APPLICATION FOR A NON MATERIAL AMENDMENT UNDER SECTION 96A OF THE TOWN AND COUNTRY PLANNING ACT (1990) ACT TO REF. 75111/APP/2022/1007 IN CONNECTION TO CONDITIONS 2 AND 10 WITH REGARDS TO:

- **ENERGY CENTRE 2**
- **ENERGY CENTRE 3**
- **CANAL ACCESS RAMP**

LAND AT BULLS BRIDGE INDUSTRIAL ESTATE, NORTH HYDE GARDENS, HAYES, UB3 4QQ

Each element is identified on the below extract:

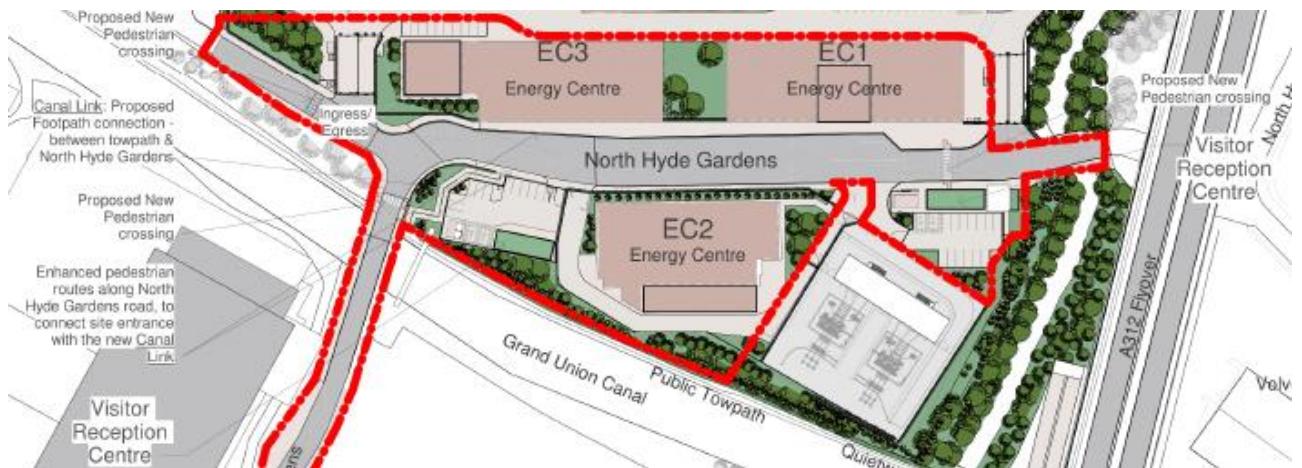
A series of alterations are proposed to Energy Centres 2, Energy Centre 3, and the Canal Access Ramp. These changes are very modest in nature but are vital to ensure that the scheme meets Ark's customer's requirements.

Alteration 1 – Energy Centre 2

- Installation of an additional staircase at the southeastern corner of the building. This will be clad in the same materials as the wider building;
- Modest refinement of the footprint of Energy Centre 2 along its western and southern boundary. As shown on the plans submitted, these changes are modest in the extreme and could reasonably be considered to be de minimis;

- To facilitate plant replacement, there is a requirement for the replacement of the brickwork along the northern elevation of Energy Centre 2 with louvres and the replacement of landscaping with planters to facilitate access;

- Reconfiguration of the green wall arrangement along the building's southern and western elevations. Importantly, the quantum of green walling (and the urban greening factor that is achieved) remains unchanged; and

- Reconfiguration of the building's internal arrangement which will mean that the heat rejection stacks will no longer be visible.

Alteration 2 – Energy Centre 3

- Reconfiguration of the green wall arrangement along the building's southern and western elevations. Importantly, the quantum of green walling (and the urban greening factor that is achieved) remains unchanged; and
- To facilitate plant replacement, there is a requirement for the replacement of the brickwork along the southern elevation of Energy Centre 3 with louvres and the replacement of landscaping with planters to facilitate access.

Alteration 3 – Canal Access Ramp and Parking Layout

Since the granting of the Slot-In permission, Ark and their project team know more about the ground conditions and both the location of existing and required underground services in this part of the site. The current canal access ramp layout has the potential for conflict between the access ramp and these services which the revised orientation avoids. This is explained further in the Technical Note (ref. HPF-0471-SWS-XX-TN-C-91004 - Technical Note) that has been prepared by HDR.
